IREDELL COUNTY HEALTH DEPARTMENT

SEPTIC IMPROVEMENT PERMIT / AUTHORIZATION TO CONSTRUCT / OPERATION PERMIT / EXISTING SYSTEM

SITE ADDRESS: 202 Atwell Drive Statesville NC 28677. PHONE: 704 578 4951 (cell) ALT. PHONE -

SUBDIVISION: Enfola Farms SECTION: 3 LOT # 20-22 LOT AREA: 8.385 Acres. DESIGN FLOW: 480 L.T.A.R.: .30

AS BUILT SKETCH

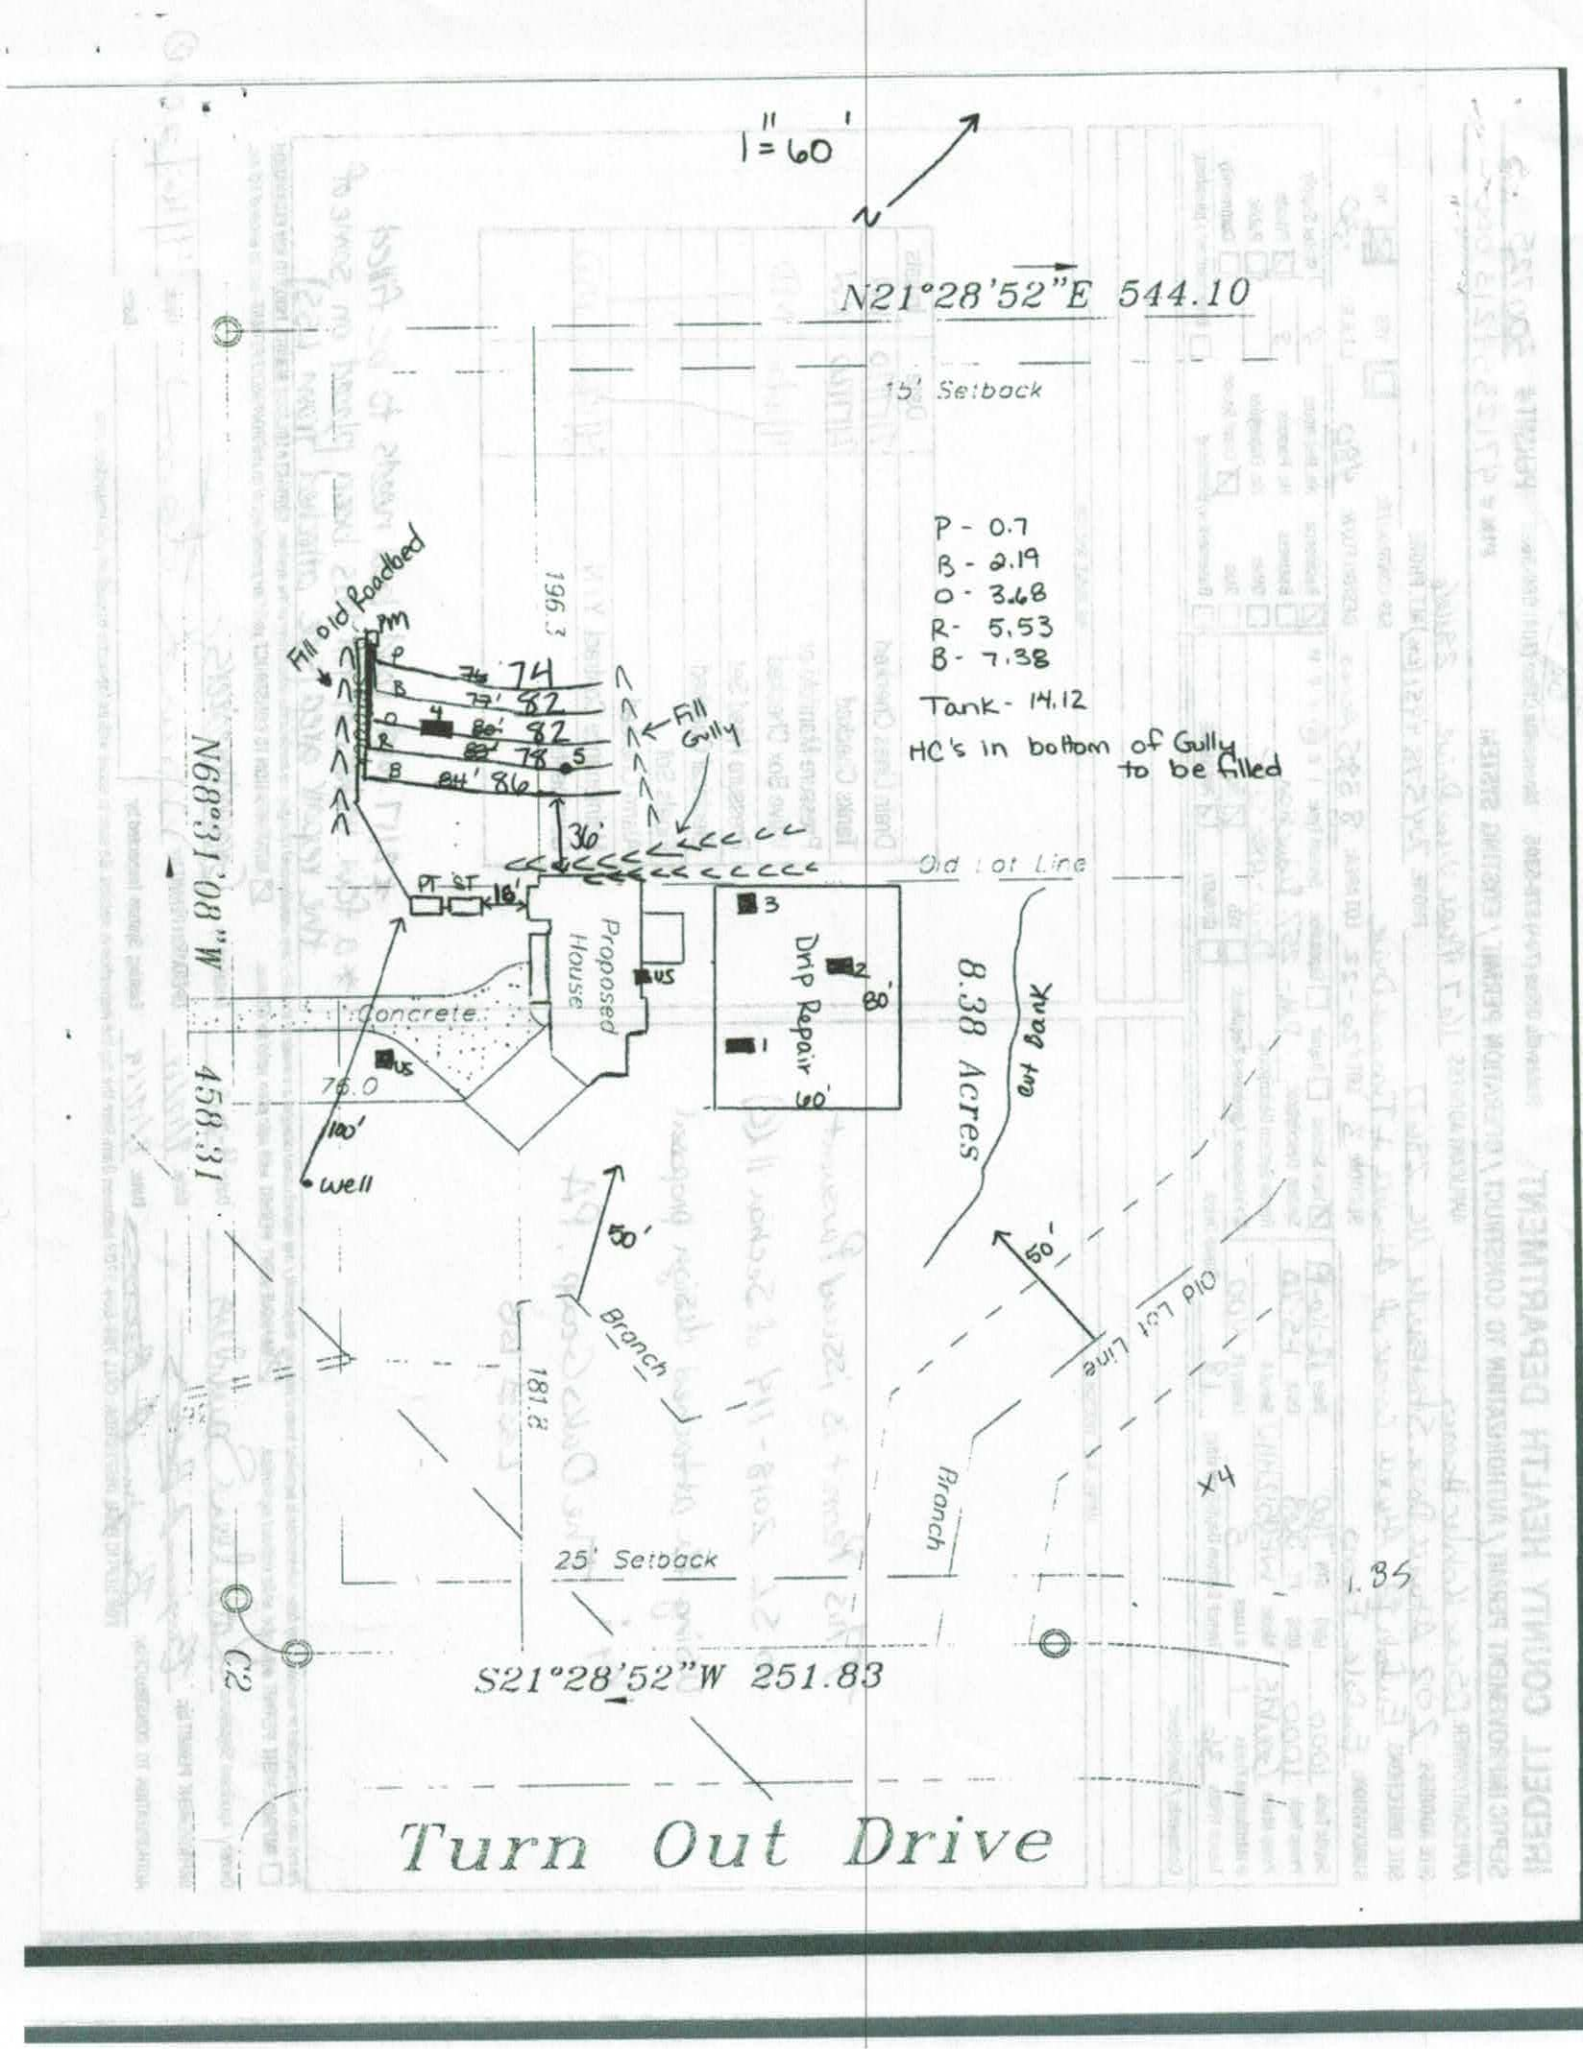
*2/17: old road bed needs to be filled
*a few inches of fill has been placed on some of the repair area (see attached from LSS)

The following changes were made to the install at 202 Atwell Dr (SL permit):
-drain lines were installed at 74', 82', 82', 78', and 86' (top drain line to lowest line)
-there is public water out there and you show a well on the site plan
***Lastly, some of the repair area has been impacted by a few inches of fill.

Please email me if you are ok with the changes of the drain lines and updated site plan not showing a well. Also, please let me know about the repair area impacted.

I'm ok with the the changes to the line lengths and a couple inches of fill material over the repair area. The well location can be marked out if necessary, although they may want an irrigation well at some point so I'd leave it on there.
